Work Order ID 129119

Item Name: Baggage Compartment Protector Wall

DART SERVICE INSTRUCTION

TO AMEND INSTALLATION INSTRUCTIONS IIN-D407-781-2 REV. A OR LATER APPROVED REVISION
AND INSTRUCTIONS FOR CONTINUED AIRWORTHINESS ICA-D407-781 REV. 3 OR LATER REVISION

**FIGURE 1 - D3879-1 BAGGAGE COMPARTMENT WALL
PROTECTOR - ALTERNATE INSTALLATION**

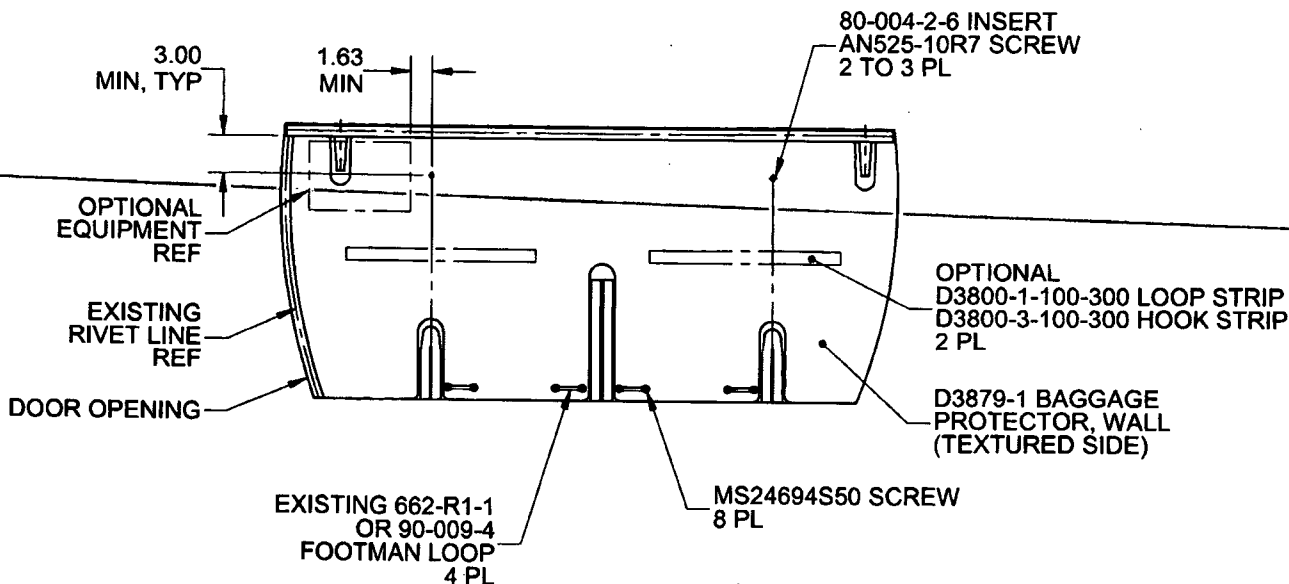
In some aircraft, the top portion of the D206-781-041 Baggage Compartment Wall Protector Kit cannot be installed as indicated in IIN-D407-781-2. The purpose of this DSI is to provide an alternate mounting method to fasten the top portion of the D206-781-041 Baggage Compartment Wall Protector Kit.

It is acceptable to replace qty(2) D3930-1 Clips with qty(2) 80-004-2-6 Inserts. Locate and mark location of the two attachment holes on the baggage compartment wall as shown in Figure 1 of this service instruction. Install 80-004-2-6 Inserts at the marked locations in accordance with Section 3-2-12 of BHT-206-SRM-1. It is acceptable to trim the wall protectors to accommodate optional equipment or transfer attachment holes to the wall protector and install the optional equipment on top of the wall protector with longer fasteners.

Amend the D206-781-041 Baggage Compartment Wall Protector Kit parts list as follows:

Qty -061	Qty -031	Qty -041	Part Number	Description
X			D206-781-061	BAGGAGE COMPARTMENT PROTECTOR KIT (FLOOR AND WALL)
1	X		D206-781-031	BAGGAGE COMPARTMENT FLOOR PROTECTOR KIT
1		X	D206-781-041	BAGGAGE COMPARTMENT WALL PROTECTOR KIT
		2	AN525-10R7	SCREW
		2	80-004-2-6	INSERT
